LAND USE APPLICATION SUMMARY

Property Location: 2323 11th Avenue South
Project Name: Phillips Community Center Aquatics Facility
Prepared By: Hilary Dvorak, Principal Planner, (612) 673-2639
Applicant: Minneapolis Park and Recreation Board
Project Contact: Linda McCracken-Hunt, FAIA, Studio Five Architects
Request: For an approximately 8,600 square foot addition to the Phillips Community Center Aquatics Facility.

Variance	To reduce the front yard setback along 11 th Avenue South from the required 30 feet to 13 feet for the parking lot.
Variance	To reduce the front yard setback along 13 th Avenue South from the required 26 feet to 20 feet for the building addition and to six feet for a transformer.
Variance	To reduce the corner side yard setback along East 24 th Street from the required eight feet to five feet for the parking lot.
Variance	To reduce the north interior side yard setback from the required seven feet to four feet for a trash enclosure.
Variance	To increase the impervious surface maximum from 60 percent to 74 percent.
Variance	To reduce the minimum parking requirement from 106 spaces to 92 spaces.
Site Plan Review	For an approximately 8,600 square foot addition to the

UTILITY PLAN

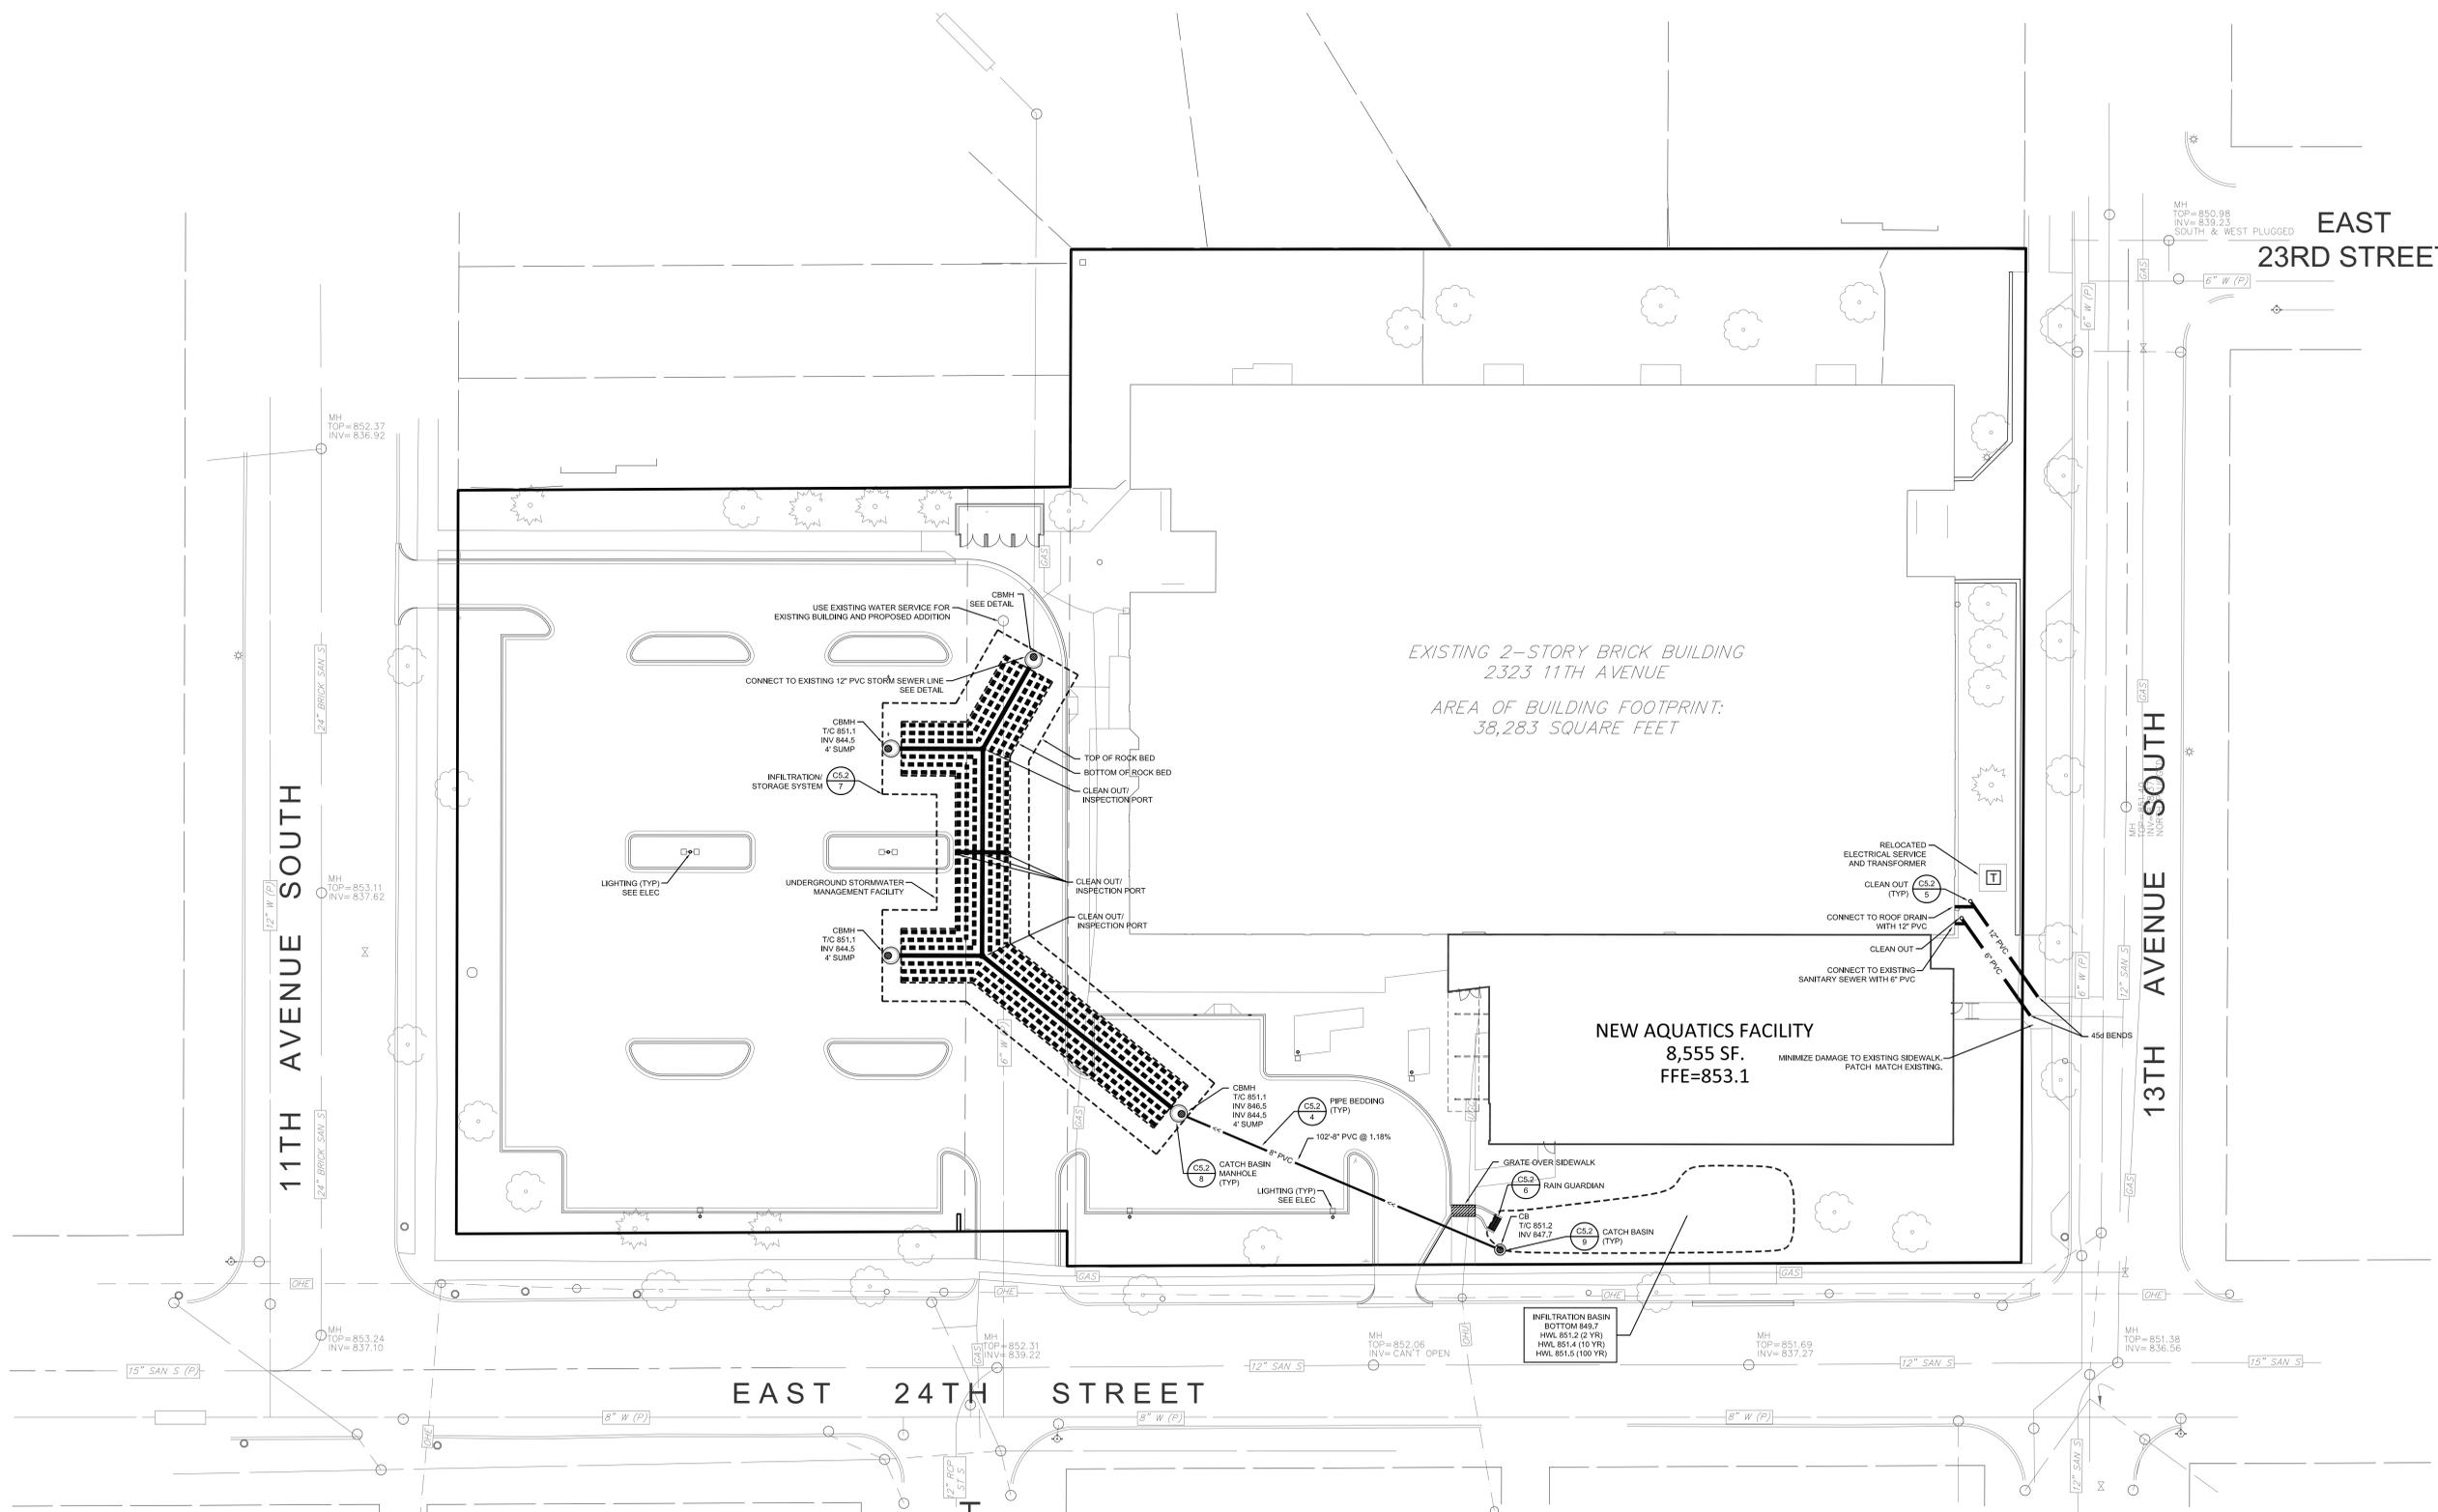
- Please provide a copy of the MIDS calculator output referenced in the Stormwater Management Report.
- Utility Connections: Please show the existing storm sewer connection on the Utility Plan along with relevant information on the service (pipe type, size, inverts, etc.).

- The existing storm sewer on west side of the property should be shown on the plans. This pipe should either be removed or abandoned in place, per City standards. It appears one CB located on the line is proposed to be abandoned in place. Records indicate there is another structure possibly located within the property.

- Please identify the location of the existing roof drains on the building.
- Non Stormwater Discharges: Detail all mechanical and non-stormwater discharges. Non-stormwater discharges are not permitted unless approved by the City of Minneapolis. Non-stormwater discharges not declared and approved will not be permitted. If there currently are none and nothing is proposed declare this status on the plans.

1 ELECTRICAL SITE PLAN WITH PHOTOMETRICS
E001 1" = 20'-0"

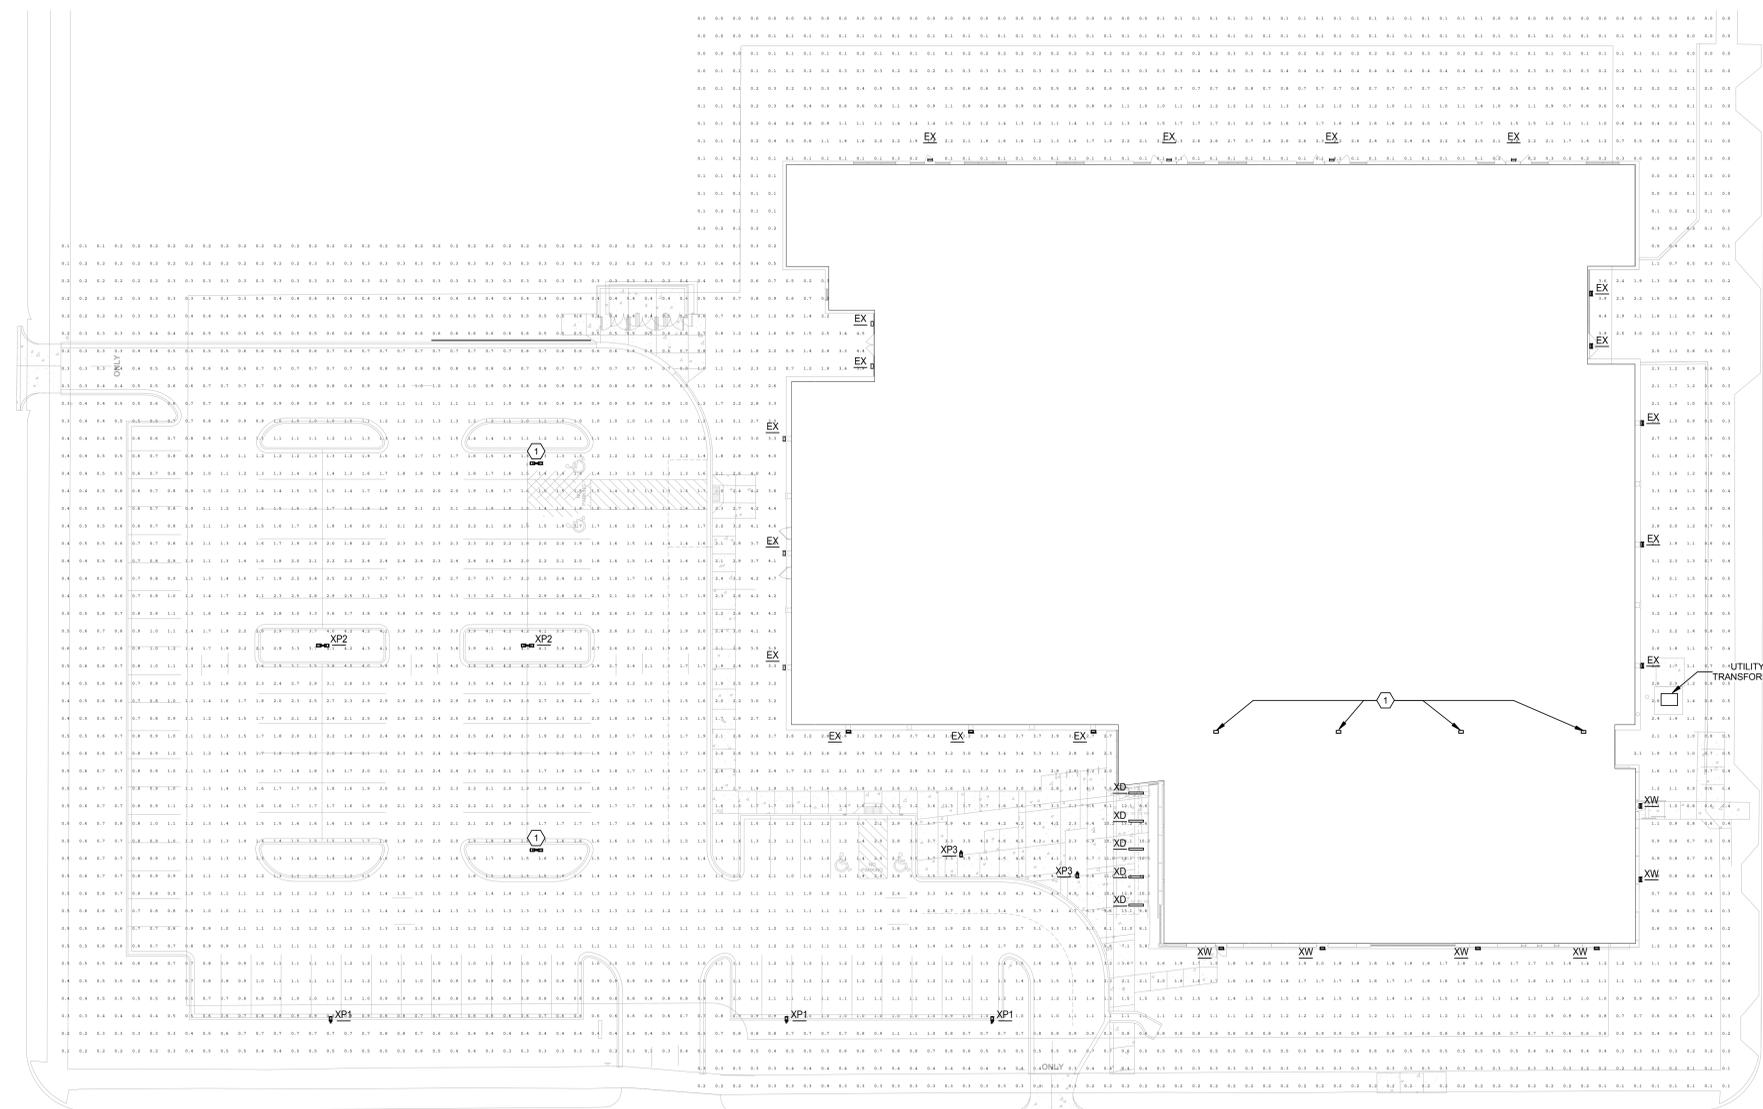
- The lighting plan showing footcandles was submitted as part of the application materials. The lighting levels are in conformance with the standards of Chapter 535, Regulations of General Applicability. CPED is recommending that exterior lighting fixture details be provided to ensure that the height of the lights are in conformance with the standards of Chapter 535, Regulations of General Applicability.

8. Exterior lighting fixture details shall be provided to ensure that the height of the lights are in conformance with the standards of Chapter 535, Regulations of General Applicability.
9. There shall be at least 20 percent clear glass on the East 24th Street elevation.
10. EFIS may be used on just that portion of the existing building above where the addition will be constructed.
11. There shall be at least 20 canopy trees provided on the site. In addition, the minimum shrub requirement of 153 shall be met on site.
12. Additional shrubs shall be planted in the landscaped yard along the north property line where there aren't any existing trees. The landscaping shall meet the landscaping and screening standards of Chapter 530, Site Plan Review.
13. One additional tree, for a total of five, shall be planted between the front property line and the parking lot along 11th Avenue South.

1 PLANTING PLAN
Scale: 1" = 20'

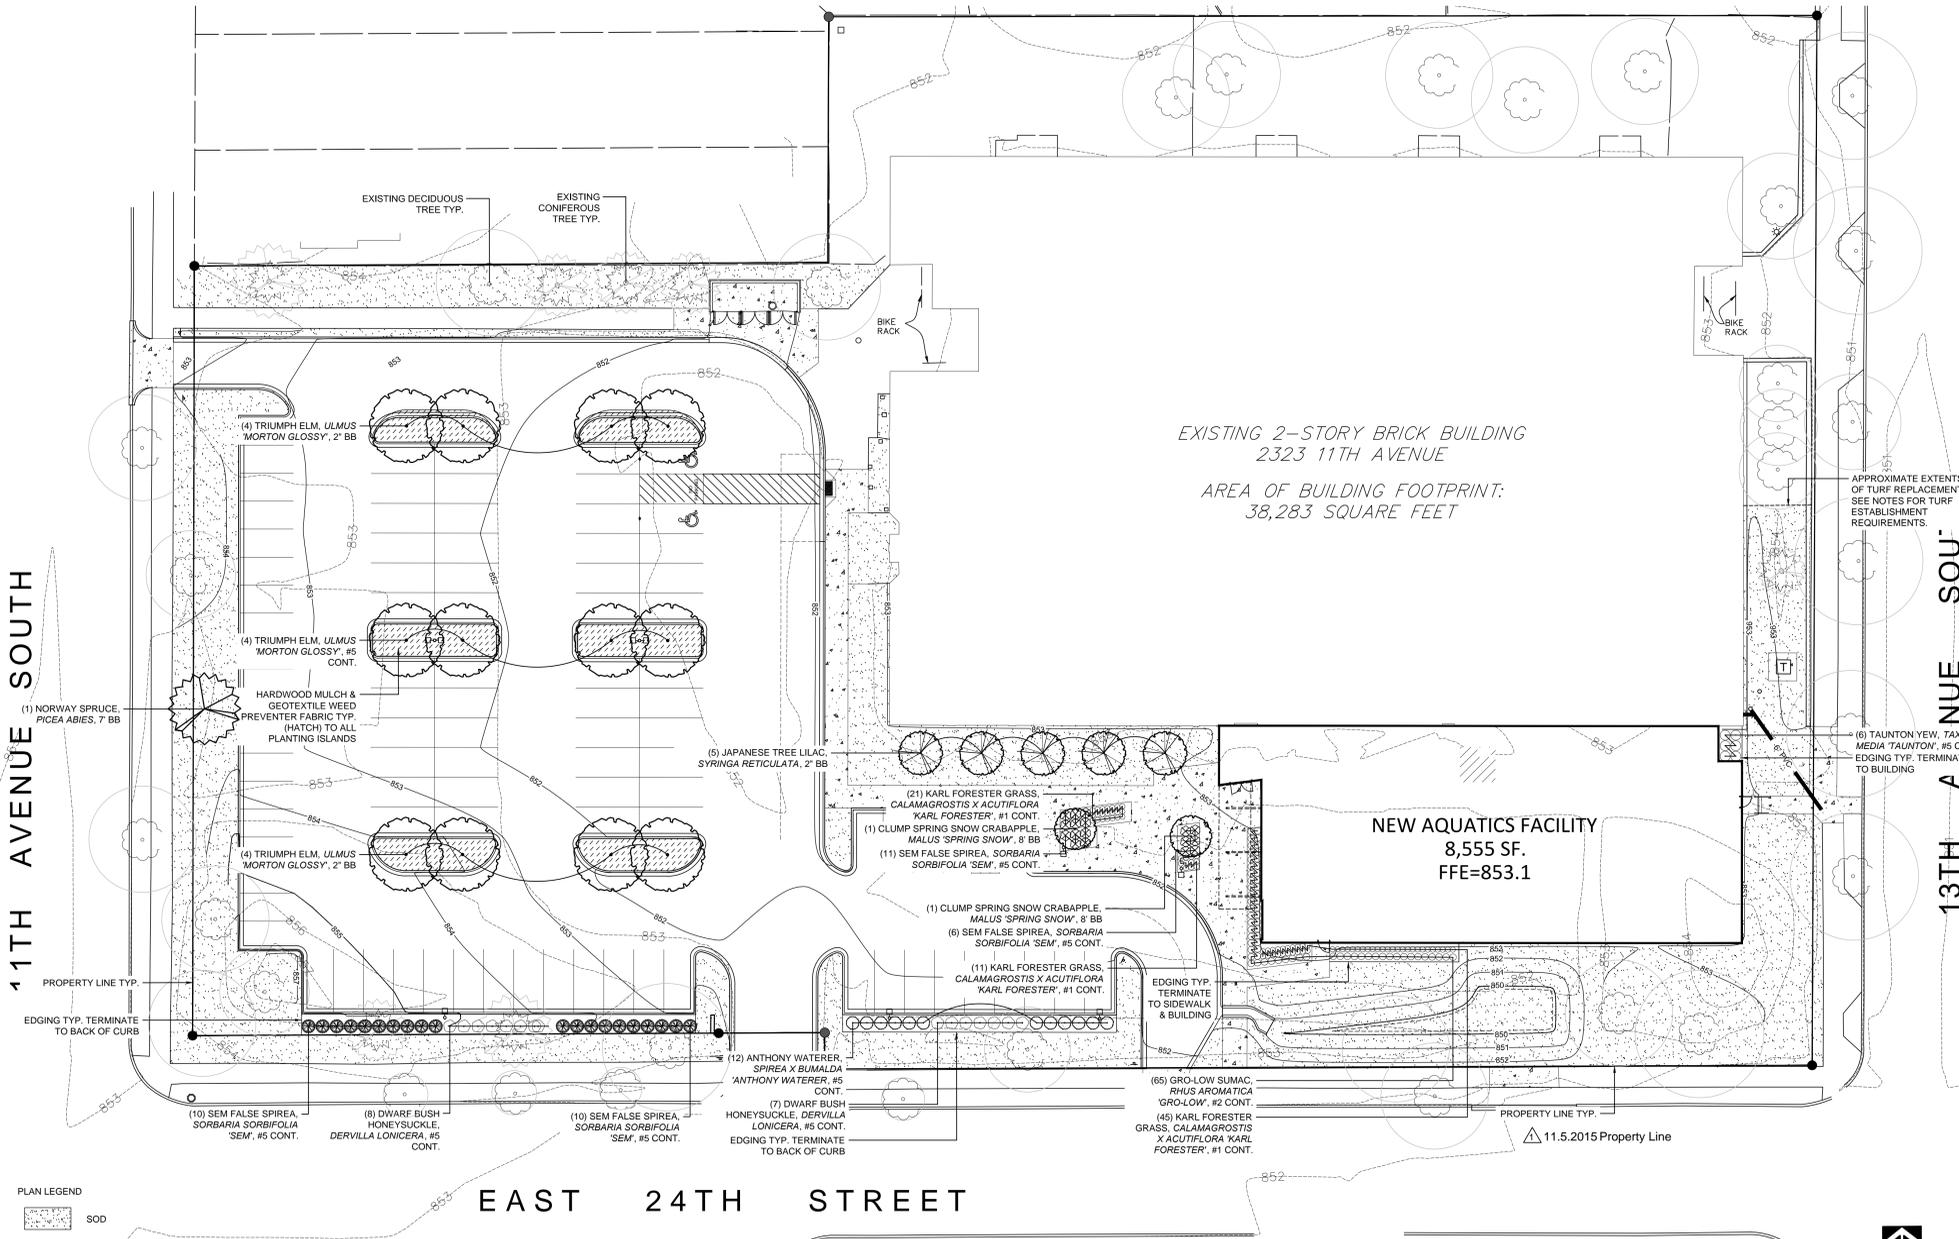
- The zoning code requires at least one canopy tree for each 500 square feet of required green space and at least one shrub for each 100 square feet of required green space be planted on the site. The tree and shrub requirement is 31 and 153 respectively. The applicant is proposing to plant 13 canopy trees and 129 shrubs on the site. In addition, the applicant is proposing to plant seven ornamental trees and 77 perennials on the site. Alternative compliance is required.

- **Trees and Shrubs.** The zoning code requires at least one canopy tree for each 500 square feet of required green space and at least one shrub for each 100 square feet of required green space be planted on the site. The tree and shrub requirement is 31 and 153 respectively. The applicant is proposing to plant 13 canopy trees and 129 shrubs on the site. In addition, the applicant is proposing to plant seven ornamental trees and 77 perennials on the site. The applicant is proposing to remove several existing trees in order to accommodate the building addition and expanded

parking lot. There is additional room on the site to add additional trees and shrubs. CPED is recommending that there be at least 20 canopy trees provided on the site. In addition, CPED is recommending that the minimum shrub requirement of 153 be met on site.

- **Required Screening.** Screening six feet in height and 95 percent opaque is required when a parking or loading facility is abutting or across an alley from a residence or office residence district or a permitted or conditional residential use. There are six existing trees and an existing solid wood fence located along the north property line. The fence is set back 30 feet from the front property line along 11th Avenue South. The applicant is not proposing to plant any additional trees or shrubs in this required yard. CPED is recommending that landscaping be planted between the front property line and where the solid wood fence is located to help screen the parking lot. The landscaping shall meet the landscaping and screening standards of Chapter 530, Site Plan Review. In the remaining area where there are no existing trees, CPED is recommending that additional shrubs be planted.

1 SOUTH ELEVATION
1/8" = 1'-0"

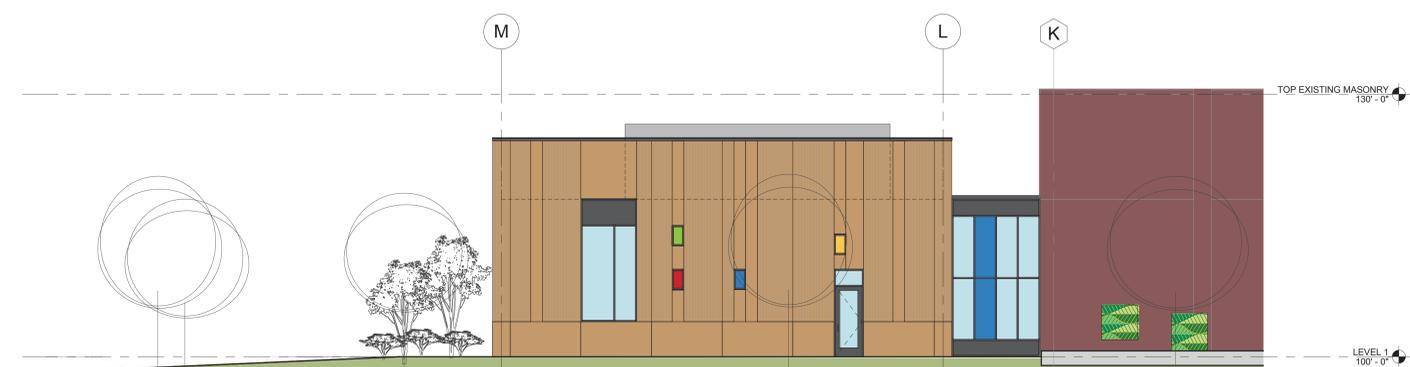
- **Evenly Spaced Windows.** The windows in the building addition are evenly spaced except along East 24th Street. The windows on this side of the building are concentrated on the west half of the addition. However, there are several windows on the east half of the addition that are glazed with film in various colors. For privacy issues the applicant is proposing to group the windows together. CPED is recommending that the City Planning Commission grant alternative compliance.

- **Durable Materials.** In order to construct the addition, the brick on the wall where the addition will be located needs to be removed. The applicant is proposing to cover the exposed portion of the existing wall with EIFS. The portion of the existing wall that will be coated in EFIS is located on the upper portion of the wall and is confined to the area just above where the addition will be constructed. CPED is recommending that the City Planning Commission grant alternative compliance to allow EFIS on just that portion of the existing building above where the addition will be constructed.
